From: Greg Shron <greg@centercreekhomes.com>
Sent: Thursday, January 22, 2026 8:54 PM
To: Bo Fairlamb <eafairlamb@gmail.com>; Gwynne Cunningham <gwynnecunningham@hotmail.com>; Breton, Andrew S. - City Council <Andrew.Breton@rva.gov>
Cc: Marc Wells <marc@centercreekhomes.com>; Brown, Whitney H. - City Council Office <Whitney.Brown@rva.gov>
Subject: 3923 Grove SUP Supplemental Info

3923 GROVE AVENUE | Richmond, VA
 Center Creek Homes

LAFAYETTE GREEN

Re: 3923 Grove Ave Special Use Permit (ORD. 2025-150)
Project Update

SITE PLAN RENDERING

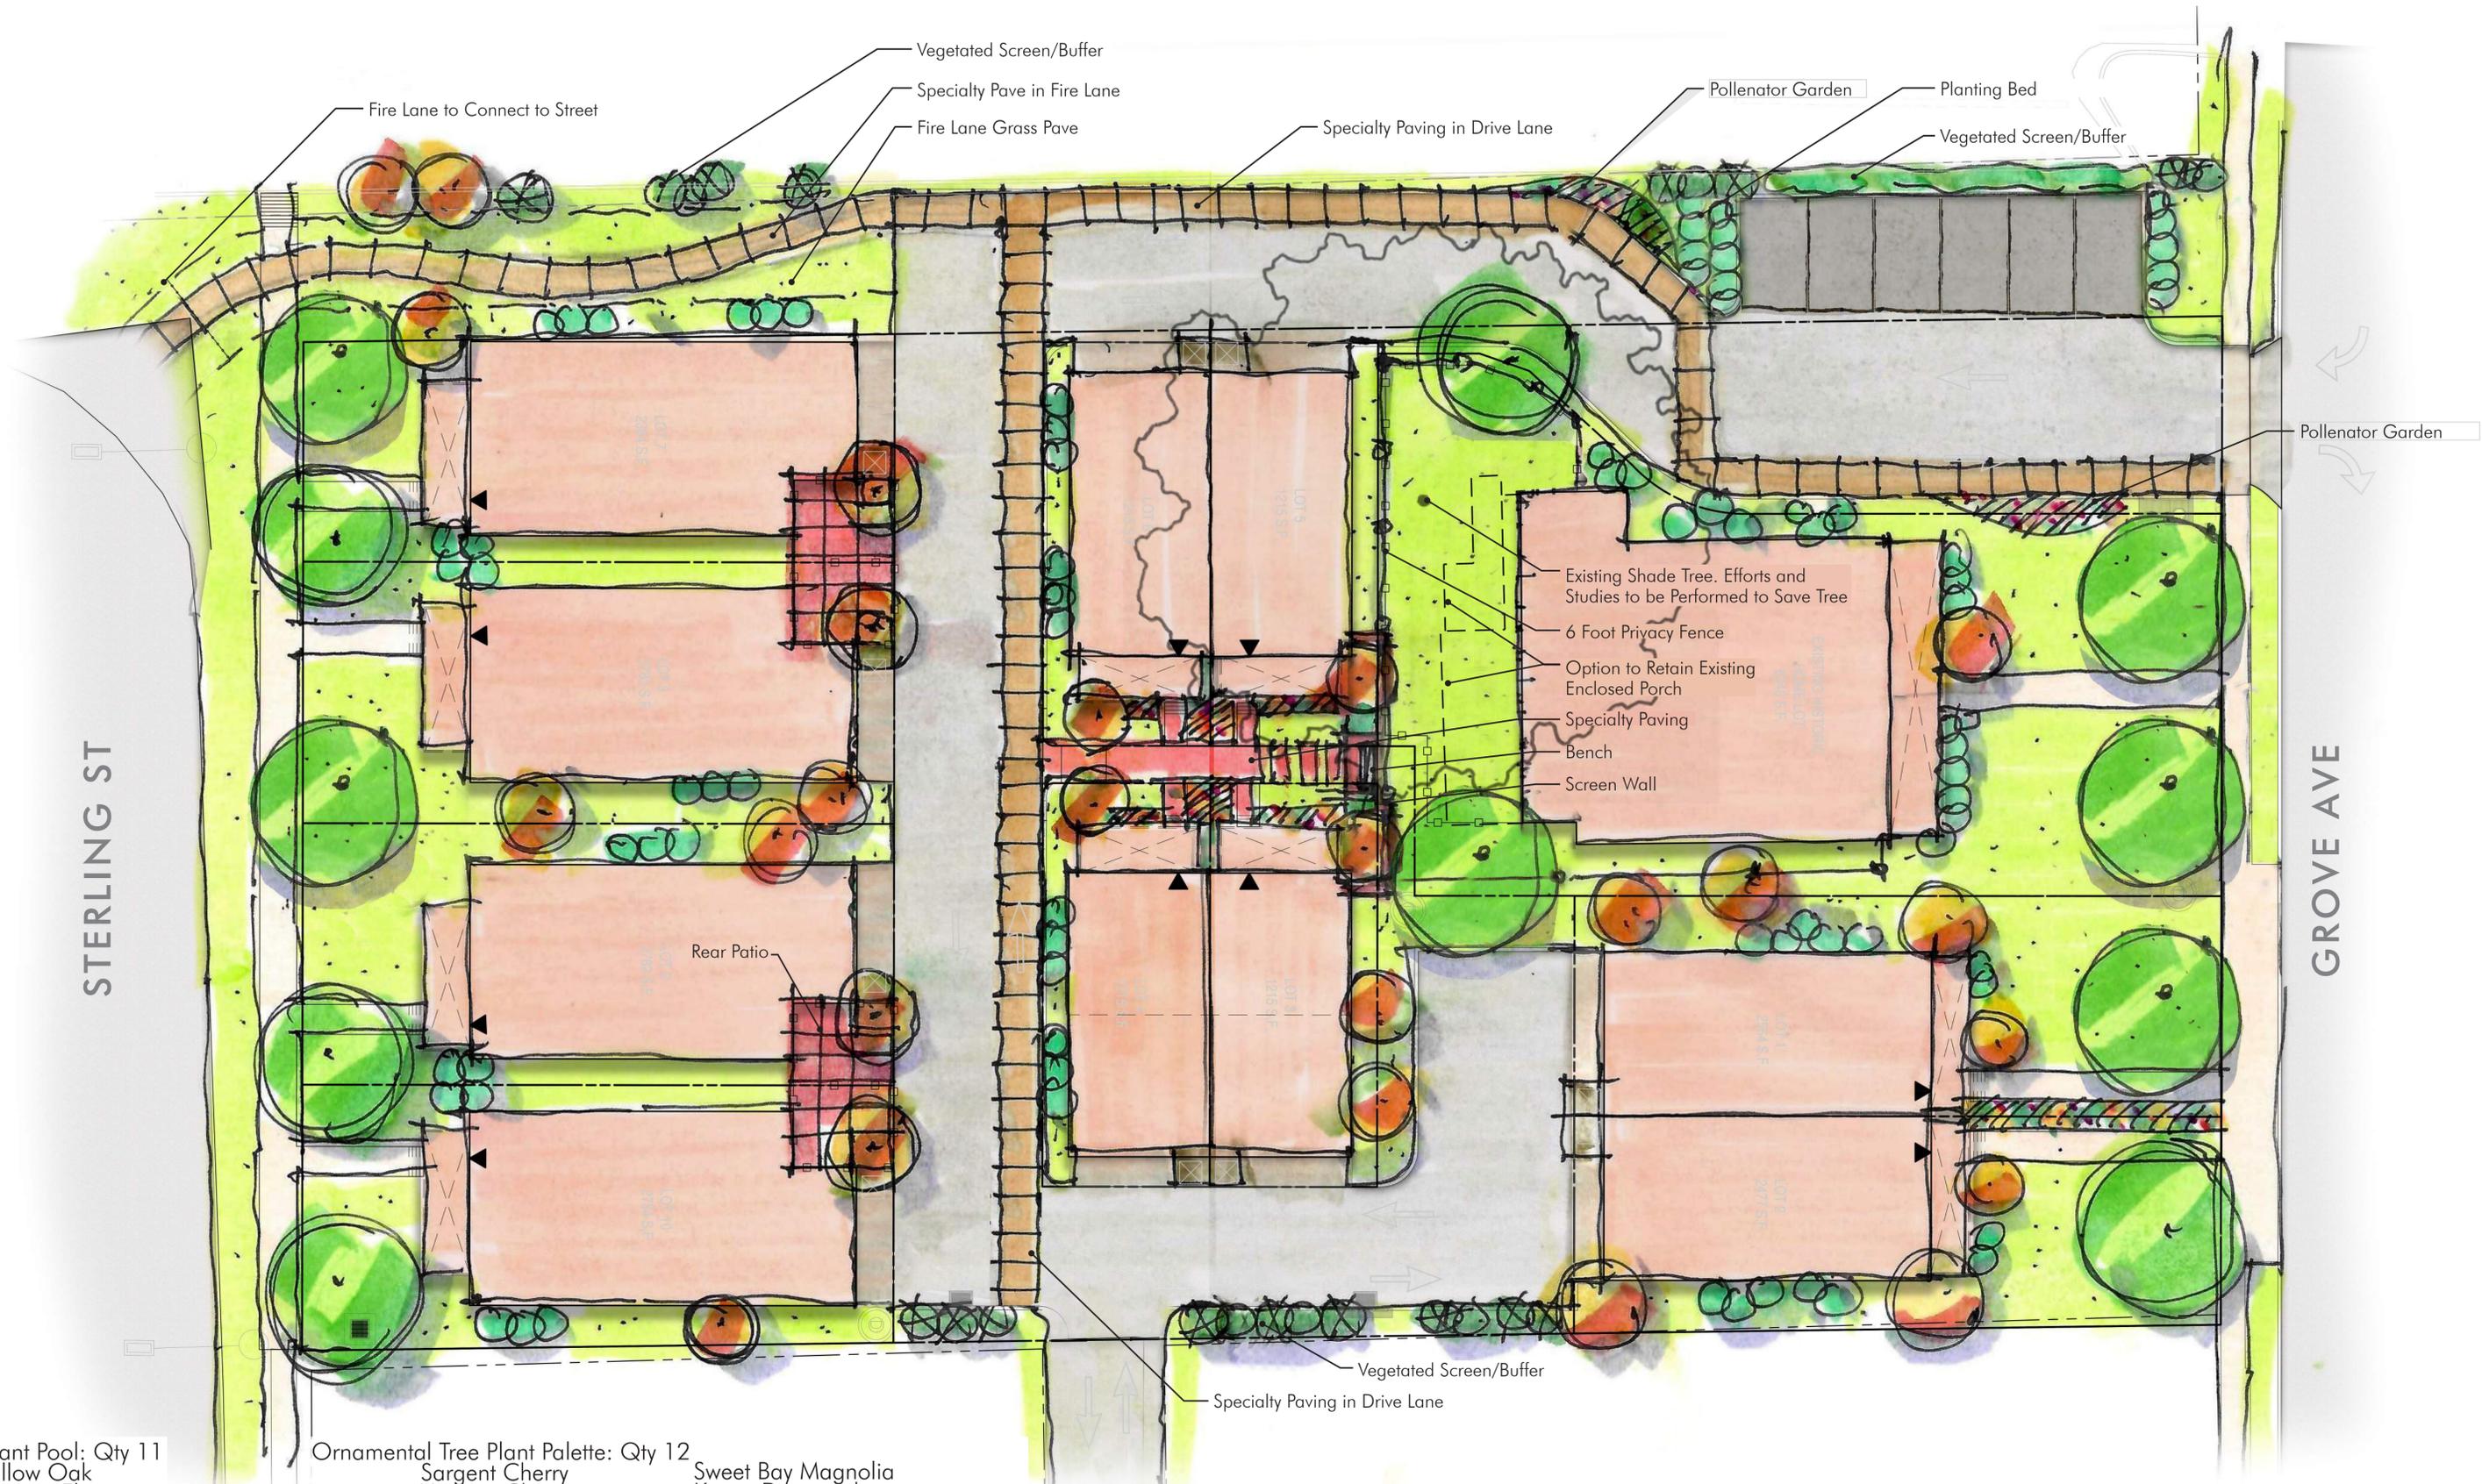
- f. Missing key notes have been added.
2. Per attached Exhibit B, the illustrative landscape plan has been adjusted as follows:
 - a. The through pedestrian connection has been updated consistent with 1.a above.

- b. Canopy trees previously shown in the existing Lafayette Street right-of-way have been removed due to the conflict with existing underground utilities and the proposed public utility easement in this area, and have been replaced with screening vegetation; a new canopy tree has been added along Sterling Street, reflecting a total of 11 proposed new canopy trees, and ornamental trees are shown as well.

- c. Minor graphic corrections were made to accurately show concrete driveways at the rear of the detached homes, along with the connection of the fire access lane to Sterling Street.

SHEET NAME:
SITE PLAN & PERSPECTIVE VIEW
 SHEET NUMBER:
A 1.0

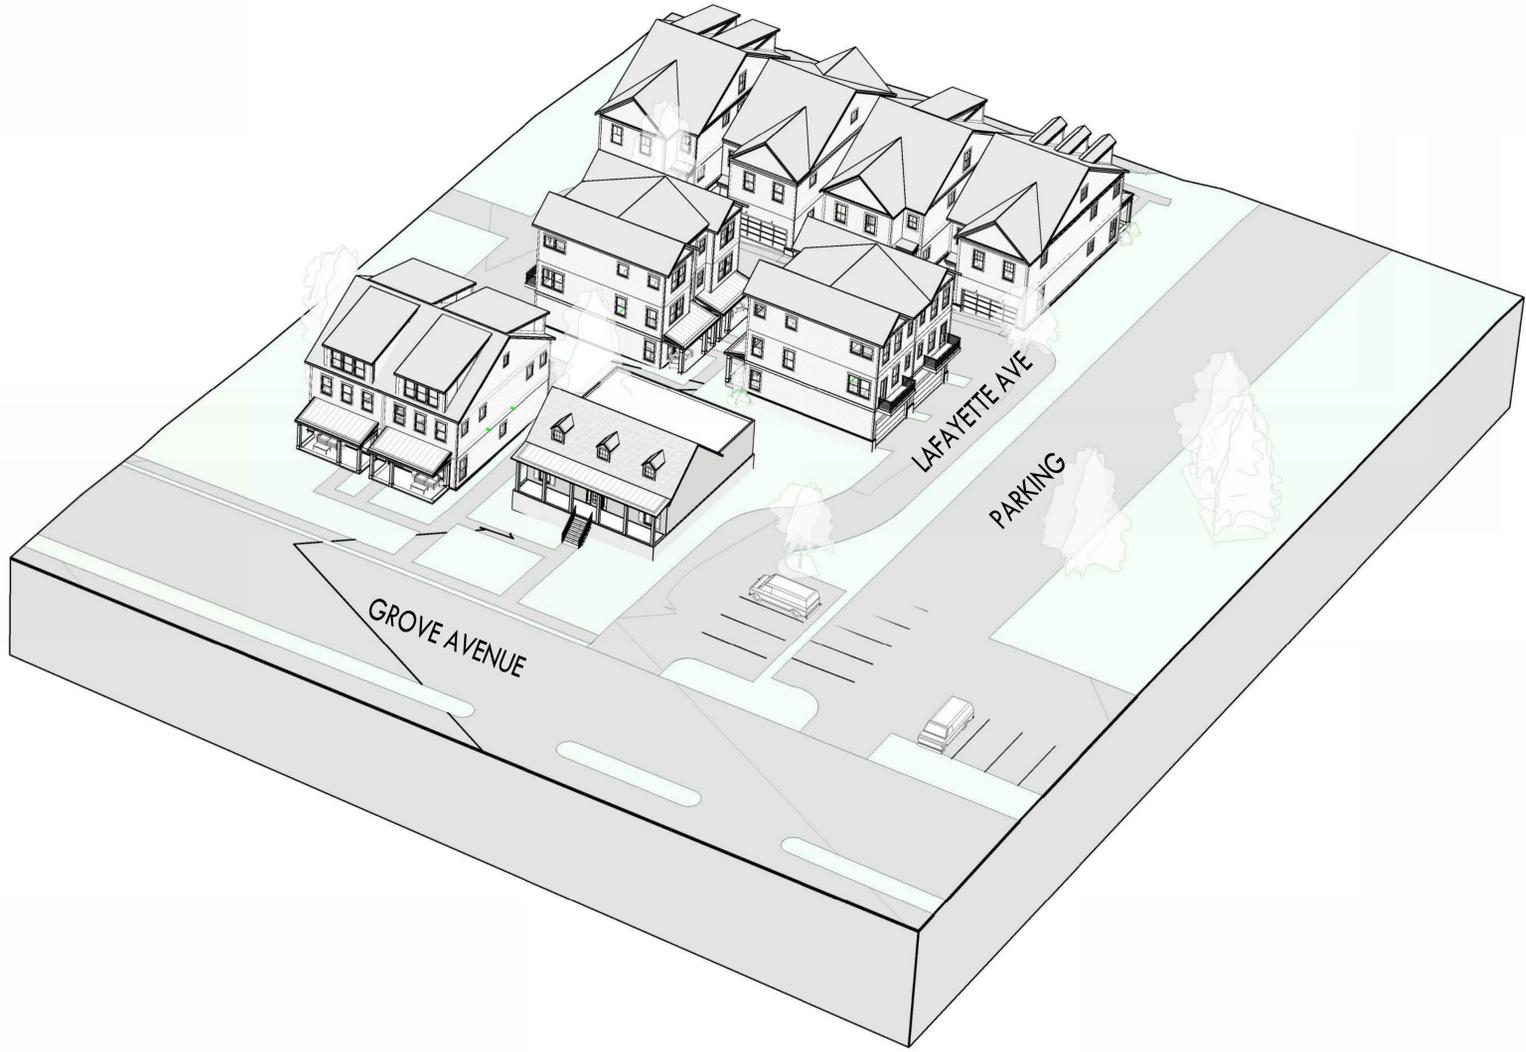
1. Per attached Exhibit A, the site layout has been adjusted as follows:
 - a. The 5' public pedestrian connection through the site has been shifted from the previous central location to within the existing Lafayette Street right-of-way to the west.

- b. The 4 detached homes fronting on Sterling Street have been shifted to be evenly spaced as a result of 1.a above.
 - c. The fire access lane "Gate and Knox Box" have been removed, with the understanding that the use of grass pavers, walkway pavers and landscaping in the area will effectively deter non-emergency vehicles from entering.

- d. Notes and graphics for the existing public alley running east from the site to Reveille Street have been revised to show the improvements extending to the maximum width approved by DPW during the permitting phase of the project, and to specify direction of drainage to Reveille Street; the transverse dimension of the intersection of this alley to the on-site alley has been increased to the full 16' width of the existing right-of-way.

- e. The note calling out street trees along Grove Avenue has been revised to "as required by DPW Urban Forestry Division;" these trees can be omitted if deemed appropriate by Urban Forestry staff during the permitting phase.
